Thursday, June 12, 2025

SUBDIVISION AUTHORITY AGENDA

MEETING NO. 23

TENTATIVE PLAN

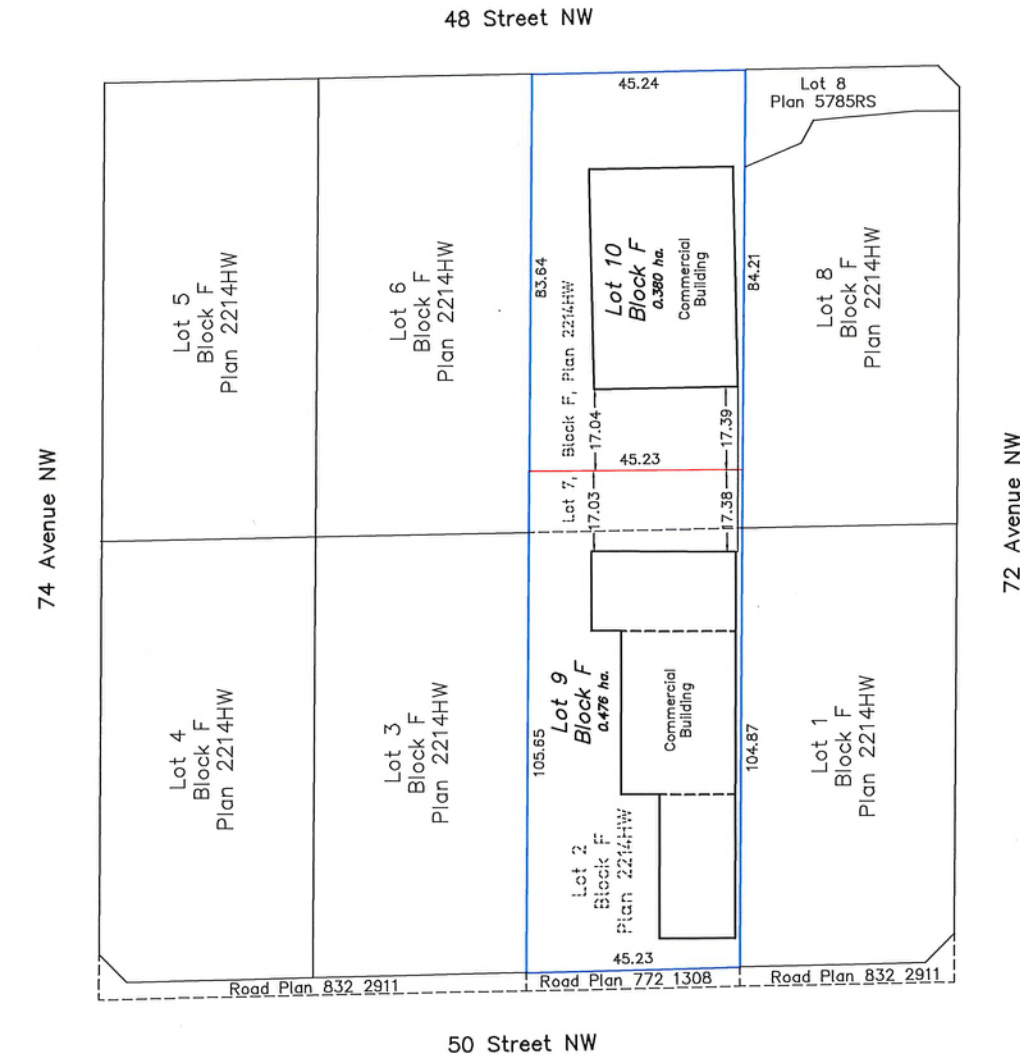
I The Subdivision by Plan is APPROVED on June 12, 2025, subject to the following conditions:

1. that the owner enter into a Servicing Agreement with the City of Edmonton for the payment of the applicable drainage assessments, pursuant to Section 655 of the Municipal Government Act (contact development.coordination@edmonton.ca); and
2. that the owner pay all outstanding property taxes prior to the endorsement of the plan of survey.

The Municipal Reserve (MR) requirement for Lot 7, Block F, Plan 2214 HW is not applicable as the subject lot is less than 0.80 hectares in area. As the subject parcel has not addressed MR with this application, should the proposed lot be part of a future subdivision greater than 0.80 ha in area, MR will be owing.

TENTATIVE PLAN

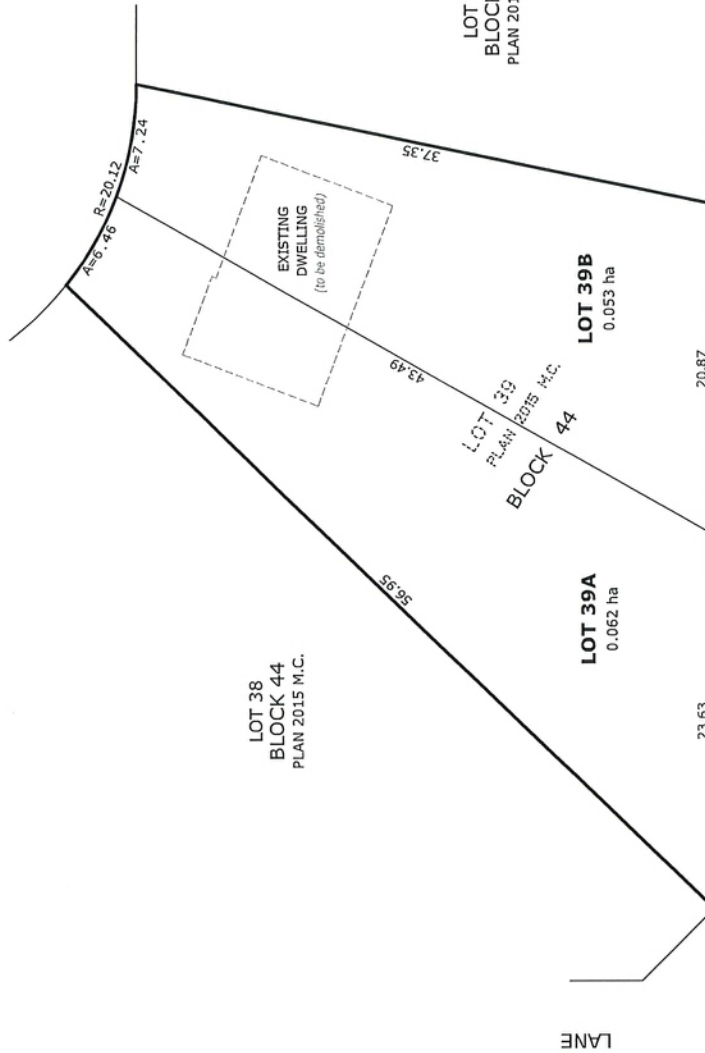
1. that the owner apply for a permit to demolish the existing dwelling prior to endorsement of the final plan. Demolition permits can be obtained from Development Services. Apply online at www.edmonton.ca/permits; and
2. that the owner pay all outstanding property taxes prior to the endorsement of the plan of survey.

- Access for future development must be to the adjacent alley as per the General Regulations (Section 6.1) in the 2.10 RS - Small Scale Residential Zone of Zoning Bylaw 20001.

- There is an existing access to 105B Street NW. Upon redevelopment of the proposed Lots, it must be removed. At that time, the owner/applicant will be required to obtain a Permit for the access' removal from the City's Development Services team. Apply online at www.edmonton.ca/permits.

- The existing services (water and sanitary) enter the proposed subdivision approximately 12.80 m west of the east property line of current Lot 39 off 105B Street NW. As per the EPCOR Drainage Services Bylaw and the EPCOR Water Services and Wastewater Treatment Bylaw, these services cannot cross the proposed property line.

- There is a deficiency in on-street hydrant spacing adjacent to the property. The applicant/owner is advised to review on-site fire protection requirements to ensure adequate coverage (contact EPCOR Water at 780-412-3955).

- There is deficient water network capacity adjacent to the property. The applicant/owner is advised to review on-site fire protection requirements to ensure adequate coverage (contact EPCOR Water at 780-412-3955).
- If power service crosses the proposed property line the owner may be required to provide a blanket easement in favour of EPCOR Distribution & Transmission Inc. If required, said easement shall be registered prior to or concurrent with the final plan of survey (contact EPCOR Land Administration Group at 780-412-3252).

TENTATIVE PLAN

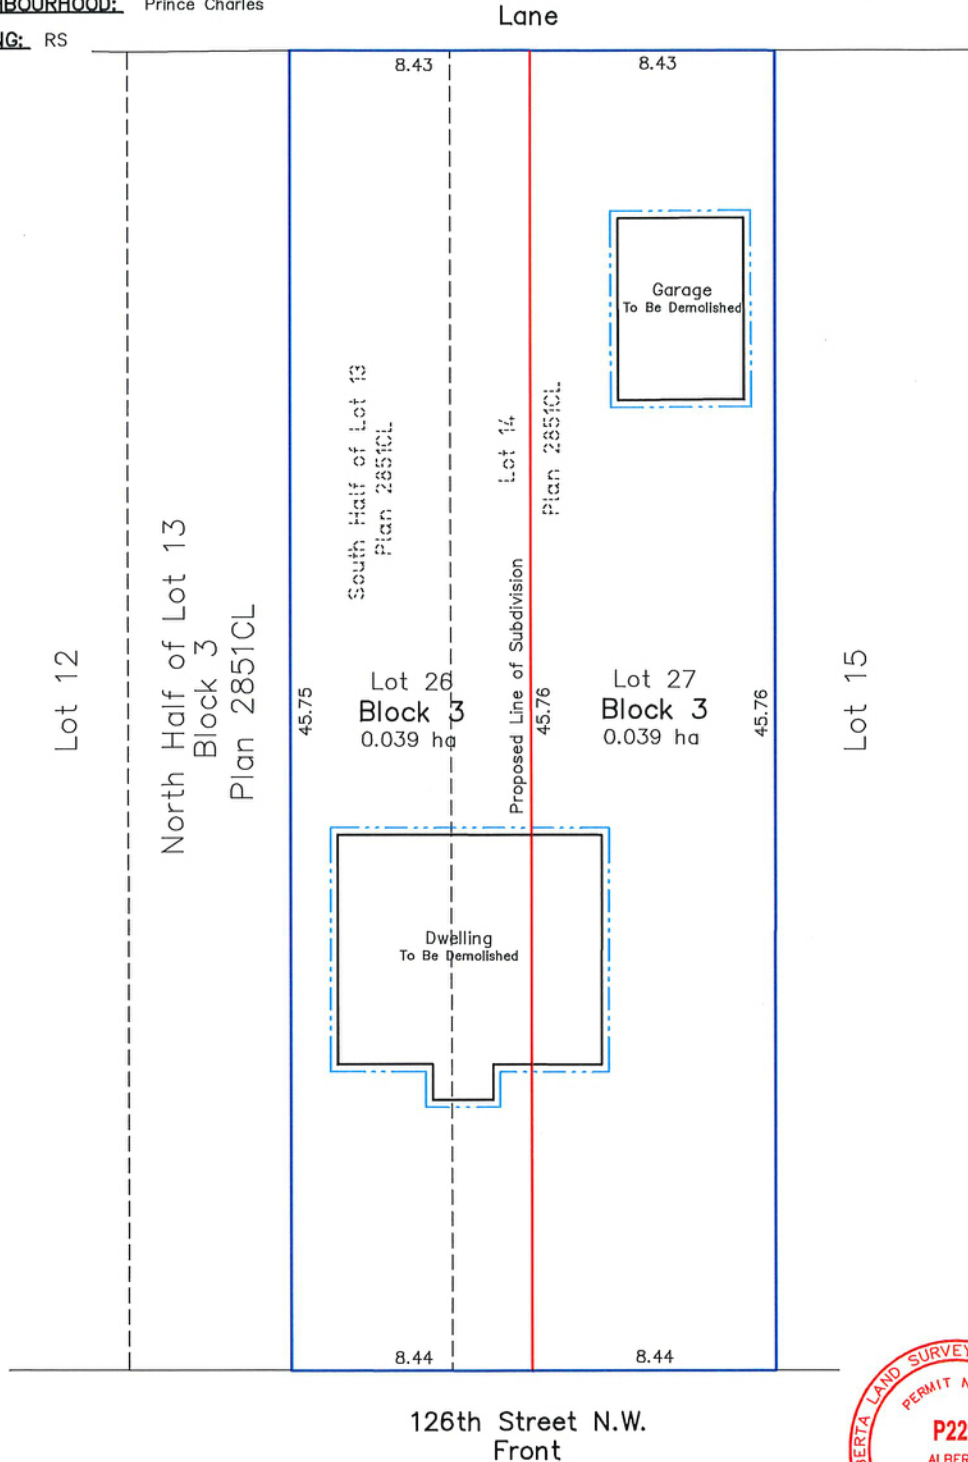
1. that the owner make satisfactory arrangements with EPCOR Water Services Inc. and EPCOR Drainage Services for the provision of separate services (water and sewer) to the proposed south lot; and
2. that the owner pay all outstanding property taxes prior to the endorsement of the plan of survey.

- The existing services (water and sanitary) enter the proposed subdivision approximately 2.17 m south of the north property line of Lot 14 off the lane. As per the EPCOR Drainage Services Bylaw and the EPCOR Water Services and Wastewater Treatment Bylaw, these services cannot cross the proposed property line.

- Overhead power lines are located on or adjacent to the subject site. It is important to prevent structural conflicts with electrical equipment. At the Development Permit stage, power poles, transformers, and other electrical equipment near the subject site must be included on all site plans and drawings. If a structure is greater than 5.5 m in height and has a setback of 4.5 m or less from the property line, please advise EPCOR Power's Customer Engineering Services (CES@epcor.com or 780-412-3128). They will provide feedback from a safety perspective, to help ensure Alberta Electrical Utility Code clearance requirements are achieved. For more

- If power service crosses the proposed property line the owner may be required to provide a blanket easement in favour of EPCOR Distribution & Transmission Inc. If required, said easement shall be registered prior to or concurrent with the final plan of survey (contact EPCOR Land Administration Group at 780-412-3252).
